# City of Richmond

## Report to Committee Planning and Development Department

Re: Application by Interface Architecture Inc. for Rezoning at 6711, 6771 and 6791 Williams Road from Single Detached (RS1/E) to Low Density Townhouses (RTL4)

Re: 14-Unit Townhouse Proposal: 6711 Williams Rd – Heritage Review Comments

**CALLING TITLE:**  
 TREE MANAGEMENT PLAN

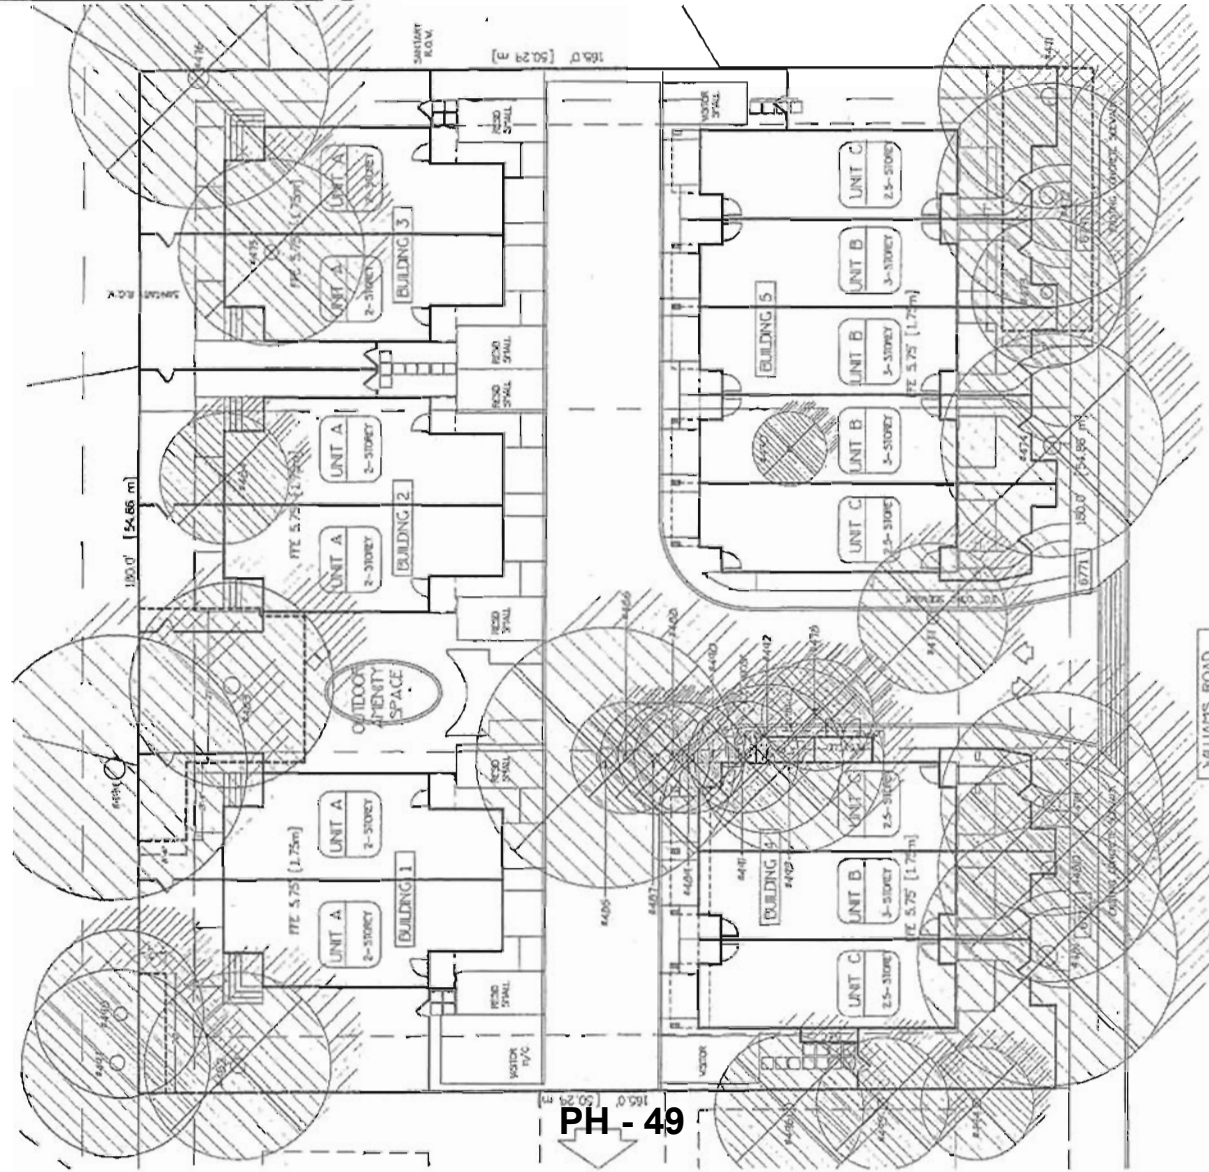
Three (3) trees located on the adjacent properties to the north are to be retained and protected (see Tree Preservation Plan in **Attachment 4**).

Yarmish House footprint relative to drive aisle

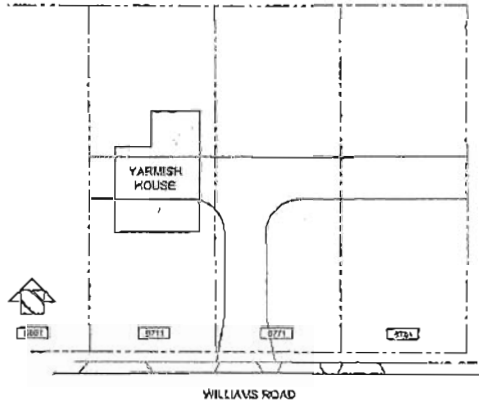
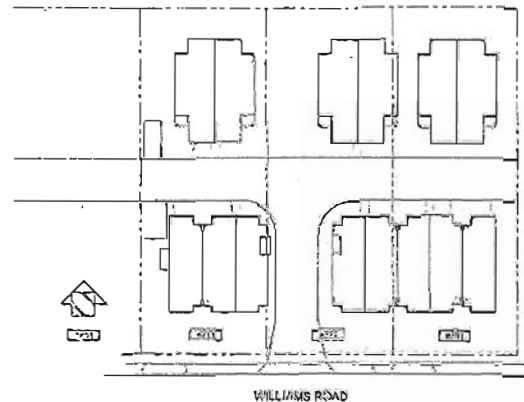
- a) Retention on original foundations: Not viable. First, the concrete foundations likely require full replacement due to its history of ad hoc basement slab renovations. Secondly, leaving the house in the original position drastically compromises the viability of the project: (i) it also sits in the middle of the site where a double-loaded drive aisle would permit two rows of dwelling units, and (ii) it sits on the west side of the assembled 3 parcels, making potential future expansion to the three western parcels virtually impossible.
